STATE OF MAINE  
DEPARTMENT OF TRANSPORTATION  
16 STATE HOUSE STATION  
AUGUSTA, MAINE 04333-0016

February 11, 2026  
Subject: Crew Quarters  
WIN: 030331.00  
Location: Medway  
**Amendment No. 2**

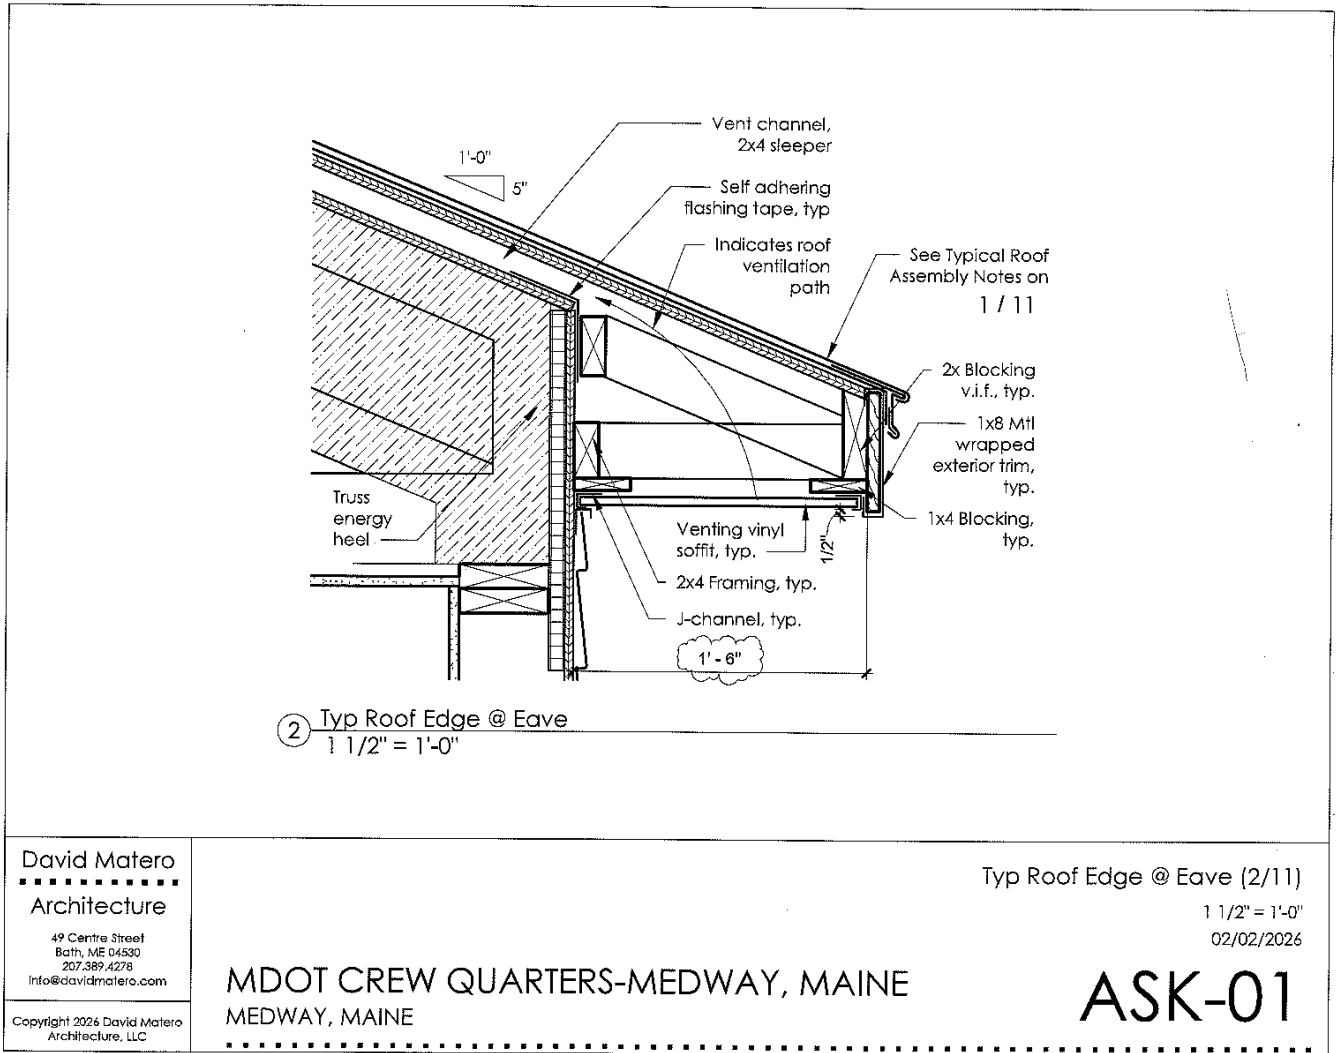
**Question:** What is overhang at eaves. I don't see a dimension on the drawings.

**Response:** See attached ASK-01 diagram.

**ASK-02**

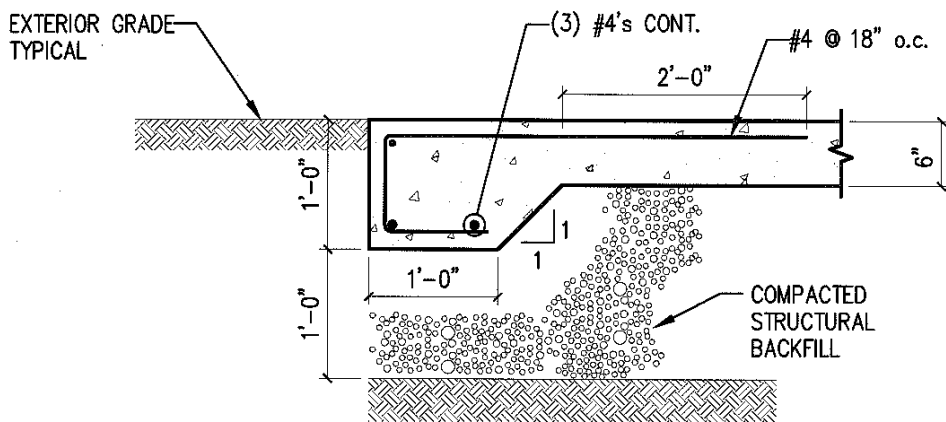
**Question:** I am looking for details regarding the propane tanks for Waldoboro & Eddington, are they buried or above ground? If they are above ground is there a detail for the pad it sits on? Also, is there a detail for the generator pads?

**Response:** All crew quarters projects propane tanks are to be placed above ground. Please see slab details for both propane and generator slabs for all locations. Please see drawing ASK-2

1. CONCRETE PAD TO BE 12 INCHES LARGER THAN THE EXTERIOR DIMENSIONS OF THE PROPANE TANKS.
2. TOP SURFACE OF THE CONCRETE PAD TO BE BROOM FINISHED.
3. CONCRETE PAD EDGES TO HAVE A TOOLED UNIFORM RADIUS.
4. PROVIDE 4,500 PSI CONCRETE FOR EXTERIOR CONCRETE PAD.
